Addendum 2.1

Tender 25-02d

This letter will serve as Addendum 2.1 for Contract 25-02d

25-02d Wilson 0.60 Lot 28, Concession 8, Township of Camden East, Lennox and Addington County

SITE PLAN: Proposed

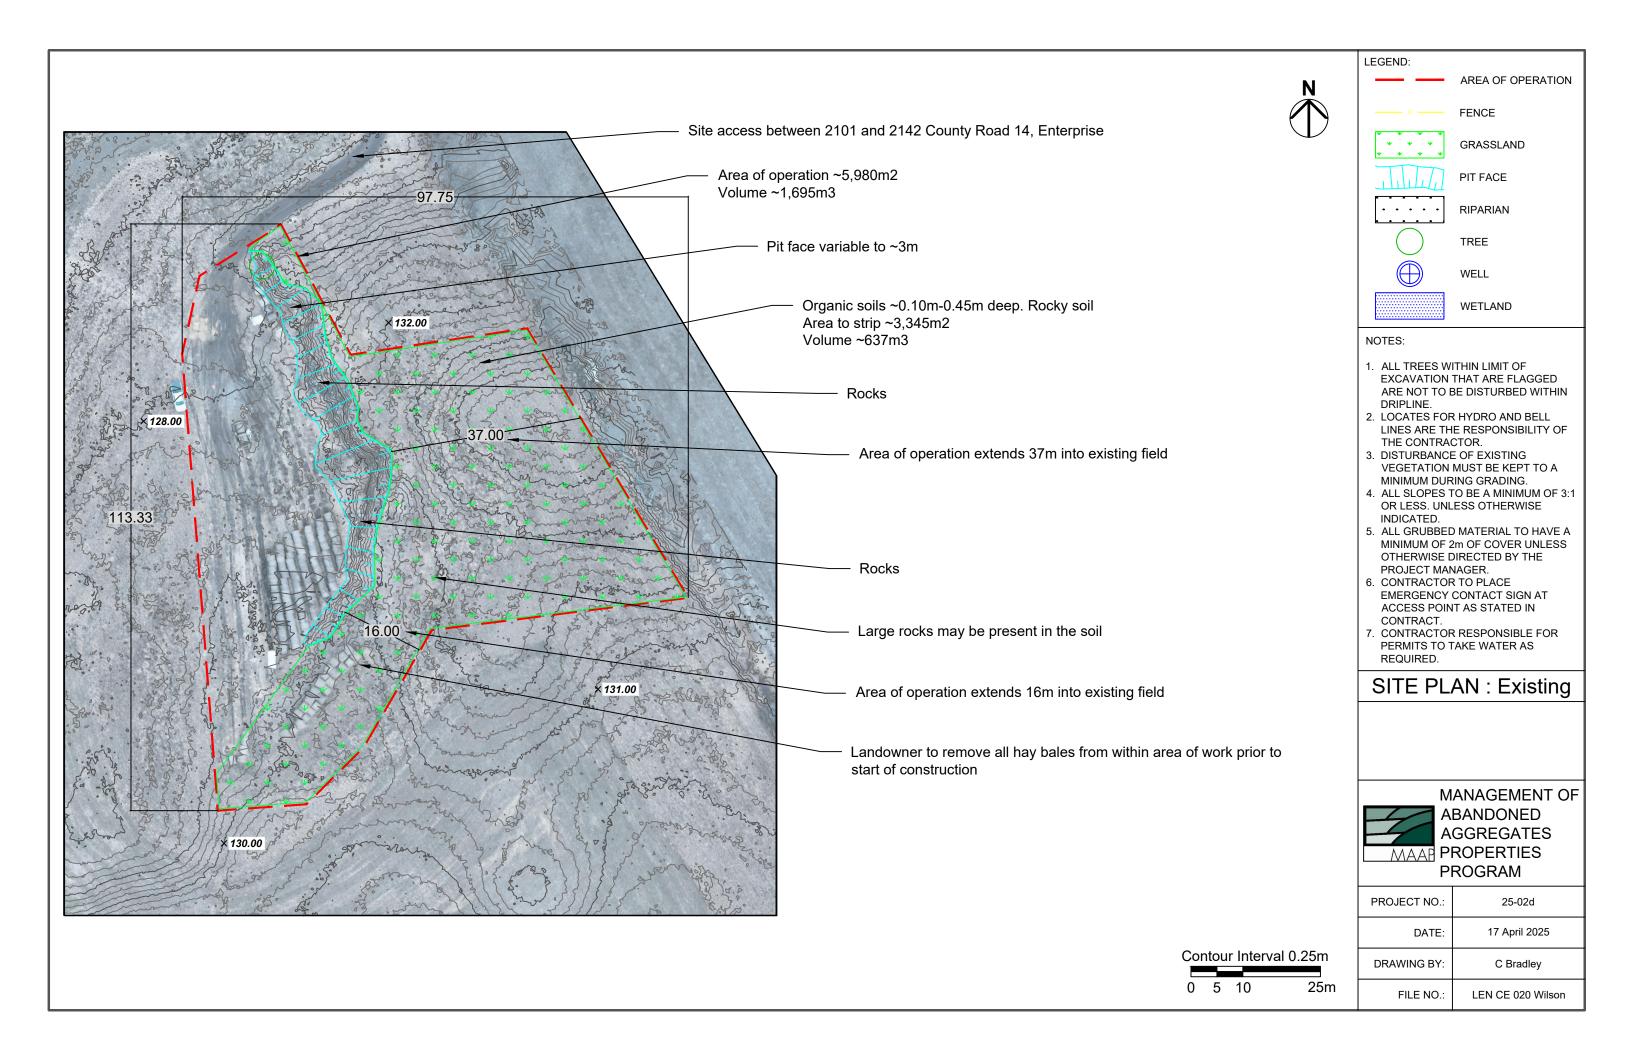
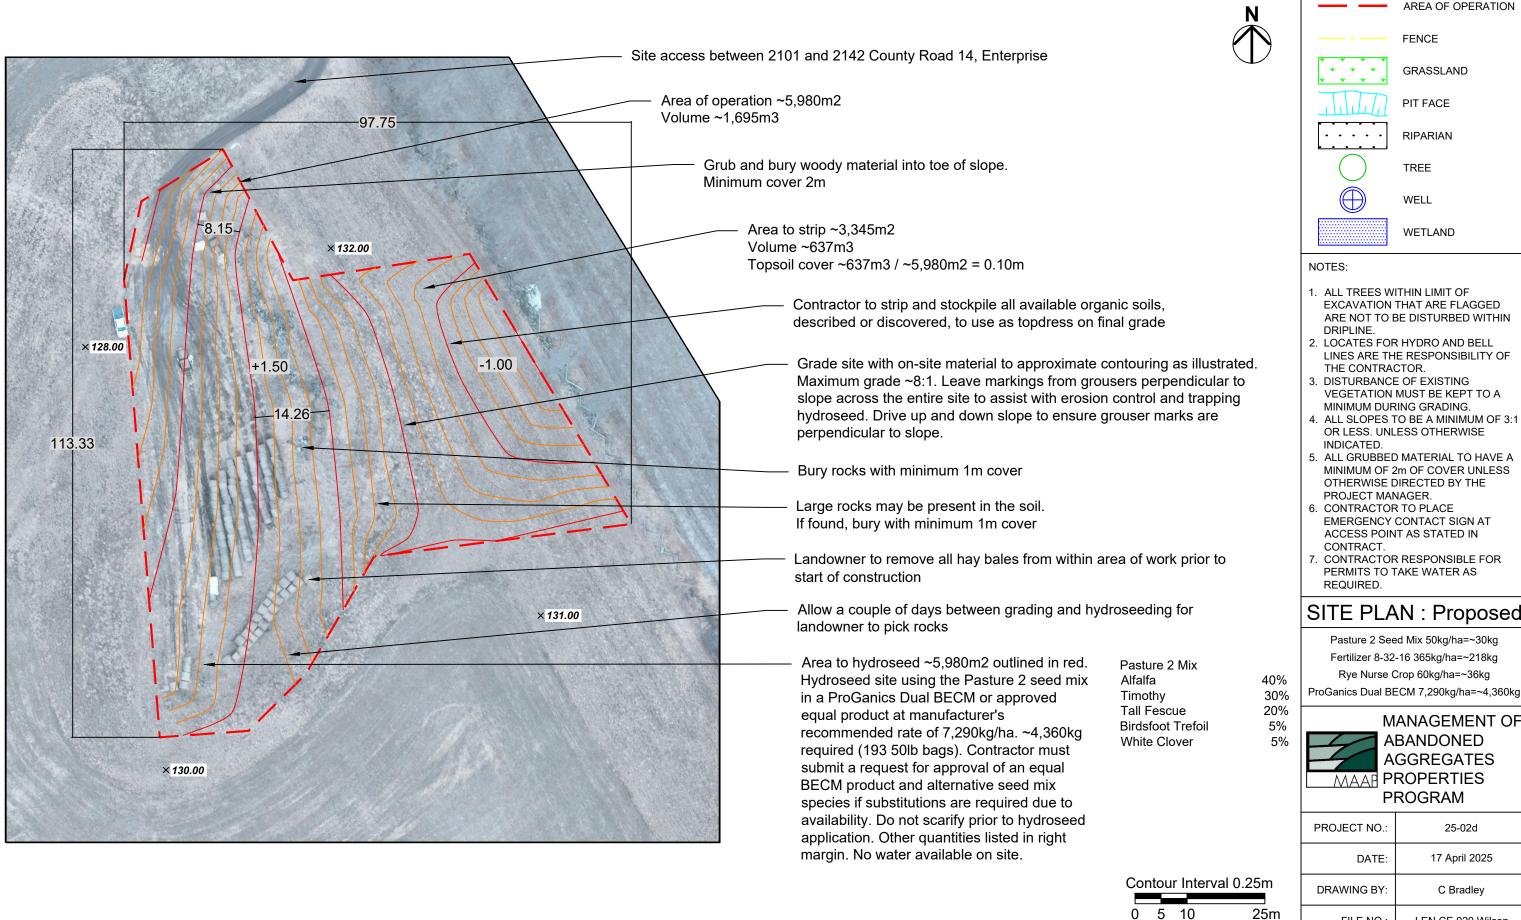
Proposed Site plan: Scatter hay from remaining hay bales across slope

Amended Proposed Site plan: Landowner to remove all hay bales from within area of work prior to

start of construction
